BULLETIN NO. 112105

TITLE: Burner Tube Change

15B Series	Nat and LP gas	Spark and Std. pilot
-------------------	----------------	----------------------

Photo 1

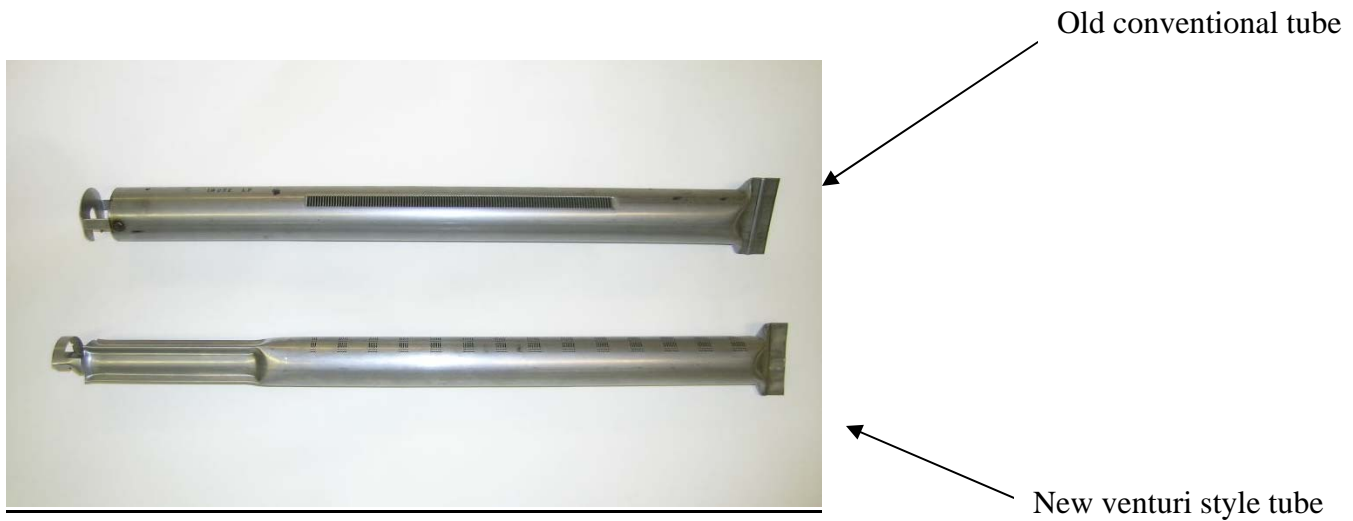
The current burner tubes used on the 15B Series Pennco Boilers have been obsoleted and replaced with a new style burner of advanced design (see photo 1). The new burners were designed for quiet operation and better performance under harsh field conditions, i.e. L.P. Gas.

The new style tubes, part no. **240005543** is a direct replacement for the old style tubes on the 15B-045 thru 15B-245 and require no burner door change.

Photo 2

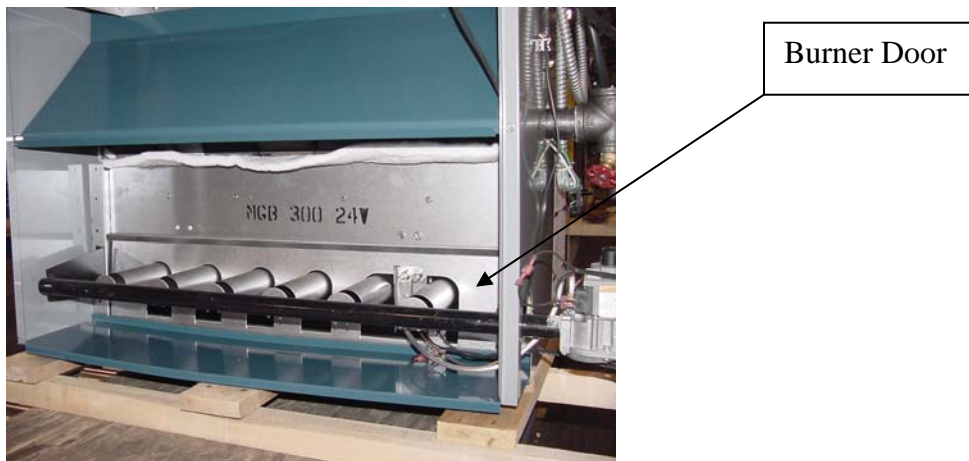
The 15B-295 requires a slight change to the burner door to accommodate the new tubes. Kit no. **550001348** is to be used in the event the new tubes are used to replace old style tubes in the field. This kit includes a new burner door along with the new burner tubes (see photo 2).
